TK0169-74-05 ESP SH/KPBP SCHEMATIC

(081114A)

Title				ESP SUPERHUB			
Size		Number			Revision		
B		TK0169-74-05			-		
Date:		13-Nov-2008			Sheet X of Y		
File:		C:\wcn\Turnkey\jobs\ESP_TK0169_SuperHub\Drawn By\TK0169_-05_ESP_SuperHub.dbb

V3.3 --> VCORE (1.27V)
DC/DC CONVERTER

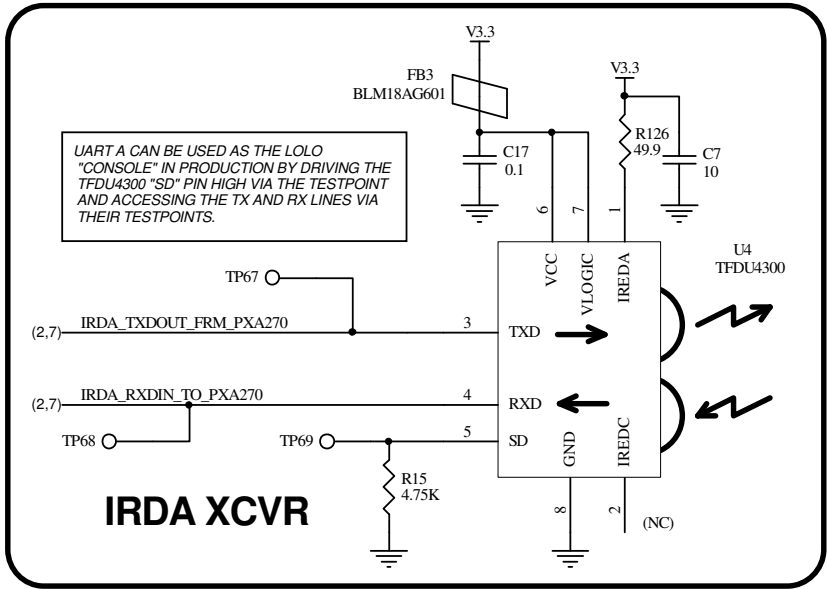
- Change PXA270 VCORE voltage from 1.5V to 1.27V
- Remove C1, C13 VCORE caps - not necessary
- Float card engine A67 (USB1_VBUS - old net was erroneously named overcrrnt_f)
- Strap CF A0 low since CE is driven for whole word only (Per LPD suggestion)
- Drive CF reset w/inverted uP_RST_OUT instead of MSTR_RST_F (per LPD)
- Add TP's on PXA270 JTAG lines (no-cost CYA for long term production needs)
- Move LCD PS ctrl from PSOC to PXA270 LCD_VDDEN & add pull down
- Change C8 (CF bulk cap) from 10uF to 22uF per LPD suggestion
- Change VCORE DC/DC input from V3.3 (SYS_EN switched) to V3.3_UNSW
- Remove PSOC drive of VCORE DC/DC enable - strapped always on
- Moved PXA270_T0_2431_CYA_1 from MFP22 to MFP27 per LPD recommendation (MFP22 not PXA I/O)

RFID MODULE, ACCELEROMETER, ETC.

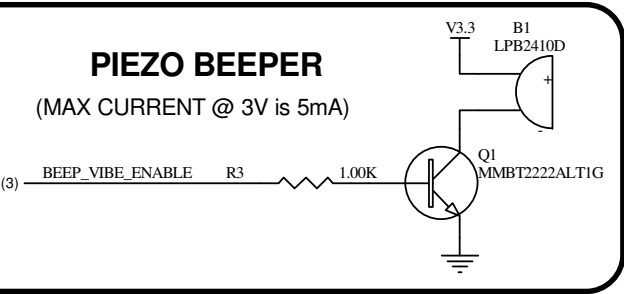
RFID REMOVED PER 5/13/08 CHRIS E-MAIL

ACCELEROMETER REMOVED 5/13
(ONLY INCLUDED FOR PRE-HUB TEST INITIALLY)

10/100BT & PWR OVER ENET MODULE

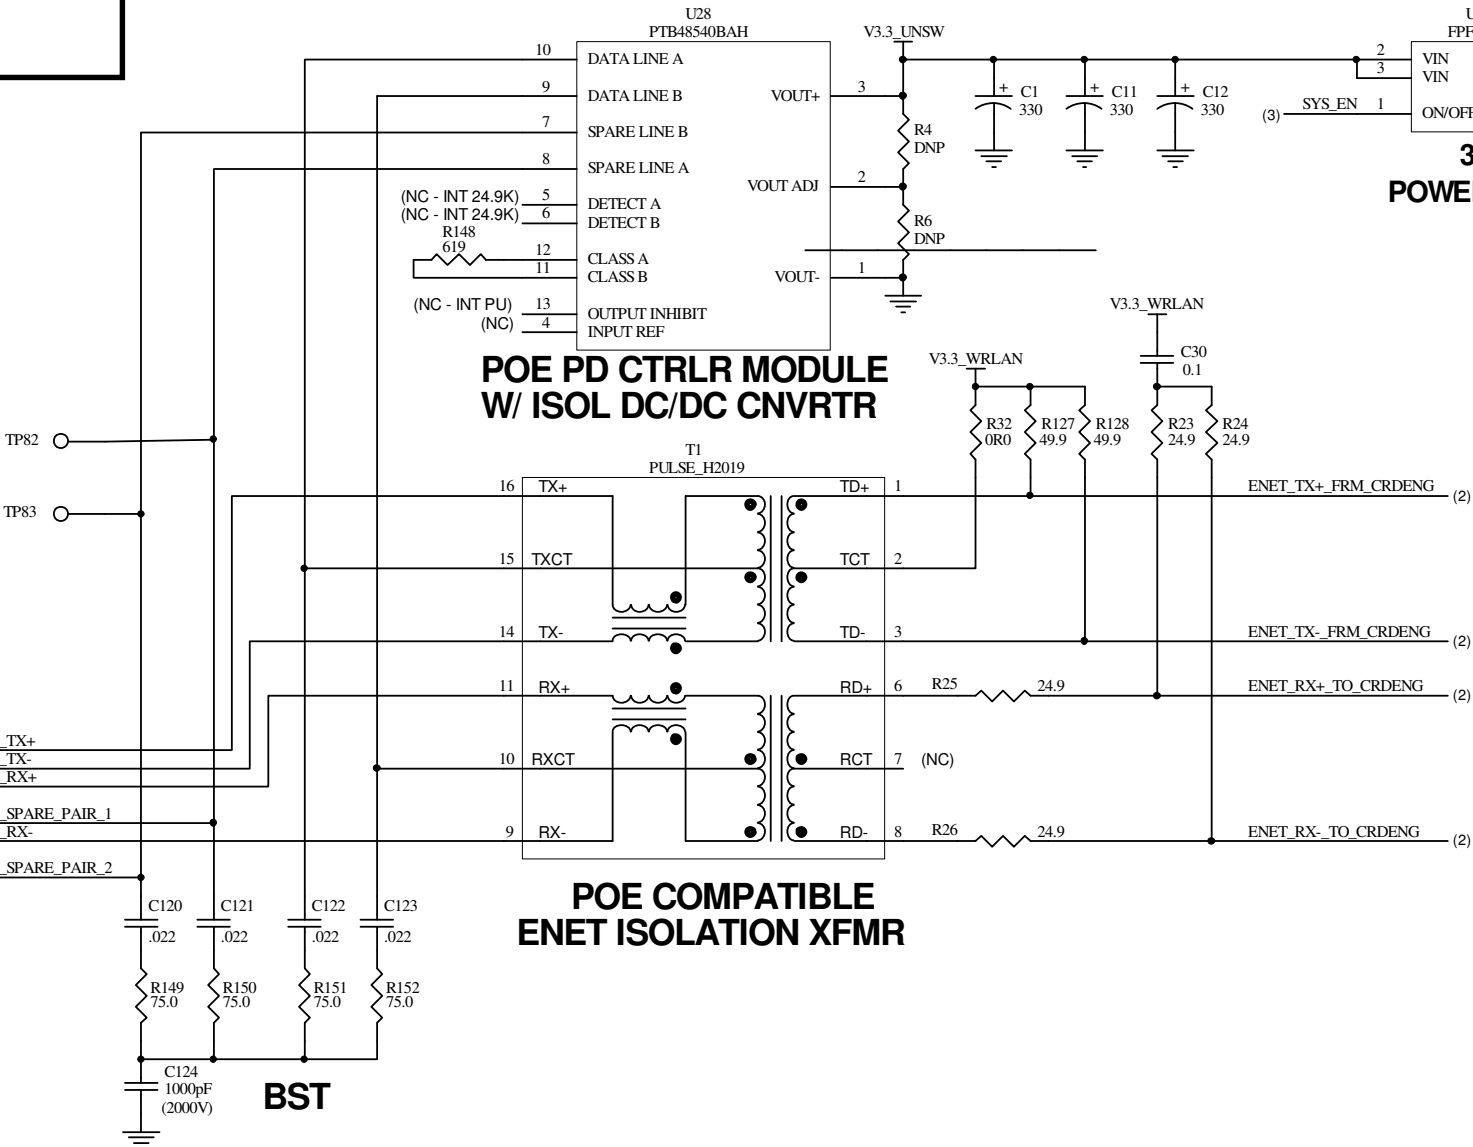
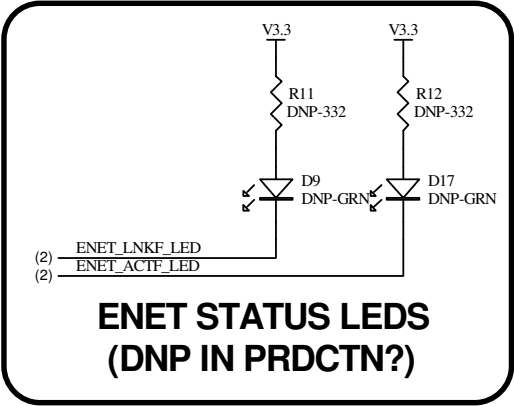
- Replace 300uF tant 3.3V bulk caps split between the inand out sides of the high side switch w/990uF alum electr. all on the input side. (see note sht 10 for details)
- Change J16 RJ45 PN(s) and footprint so it can be populated with either a vertical (in SH) or right angle (in KBP) connector.
- Add external LNA board power and TX/RX connector per Steve's inputs.

3.3V SWITCH NOTE

3.3V HIGH SIDE SWITCH ADDED 5/12/08 PER LOGICPD AND MARVELL DATASHEET GUIDANCE TO KEEP PXA270 EXTERNAL PERIPHERALS FROM BEING POWERED PRIOR TO THE PXA270 CORE AND I/O BEING UP AND "SANE" AND TO PREVENT THE PERIPHERALS FROM BACK POWERING THE PXA270 3.3V I/O AT STARTUP

3.3V BULK CAPACITANCE NOTE

PER THE LOGIC PXA270 CARD ENGINE HARDWARE MANUAL A MINIMUM OF 300uF OF BULK CAPACITANCE IS REQUIRED ON THE 3.3V RAIL FOR THE CARD ENGINE. THIS IS DUE TO A LARGE CURRENT SPIKE THAT THE CARD ENGINE REQUIRES SHORTLY AFTER POWER IS APPLIED. WITHOUT THIS CAPACITANCE, THE 3.3V SUPPLY WILL DROOP WHICH CAUSES THE PROCESSOR TO RESET AND THEN OSCILLATE THROUGH THE SAME CYCLE FOREVER. THE -04 VERSION HAD THE BULK CAPACITANCE ON THE OUTPUT SIDE OF THE SYS_EN CONTROLLED HIGH SIDE SWITCH. THAT ACTUALLY MADE THE OSCILLATION WORSE SO ALL BULK CAPACITANCE WAS MOVED TO THE INPUT SIDE OF THE SWITCH. THE MAXIMUM RECOMMENDED OUTPUT CAPACITANCE FOR THE PTB48540 POE MODULE IS 1000uF.
